SUBJECT: Campaign #100 – Kwikkee® Step Control Unit

Product Service Bulletin

Date: December 14, 2005
Subject: KSB: 05-03

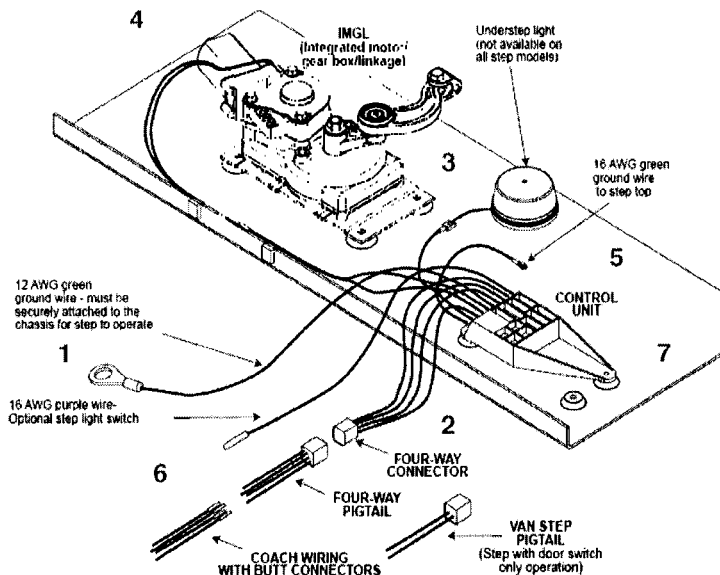
See diagram below. Step controls with a 5-digit date code ending in "a" require replacement.

Under low temperature (below 15°F) a significant percentage of controls with the 5-digit date code can cease functioning, build up excessive heat, and potentially ignite.

NOTE: Date
Code with "a"

Change

OK

If a step is inspected and found to have a control with a 5-digit date code, the control must be immediately replaced. A replacement control kit is available from Kwikkee Products. Labor claims for inspection and/or replacement should be submitted to Winnebago Industries.

1. Disconnect long green ground wire from RV chassis.
2. Unplug four-way connector from coach wiring.
3. Disconnect wire from step light connector.
4. Unplug connector from step motor.
5. Disconnect short green ground wire from step frame by removing screw.
6. Disconnect purple wire from coach wiring (not used on all coaches).
7. Remove three screws from step control mounting and remove control from step frame.
8. To install new step control follow steps 1 through 7 in reverse order.
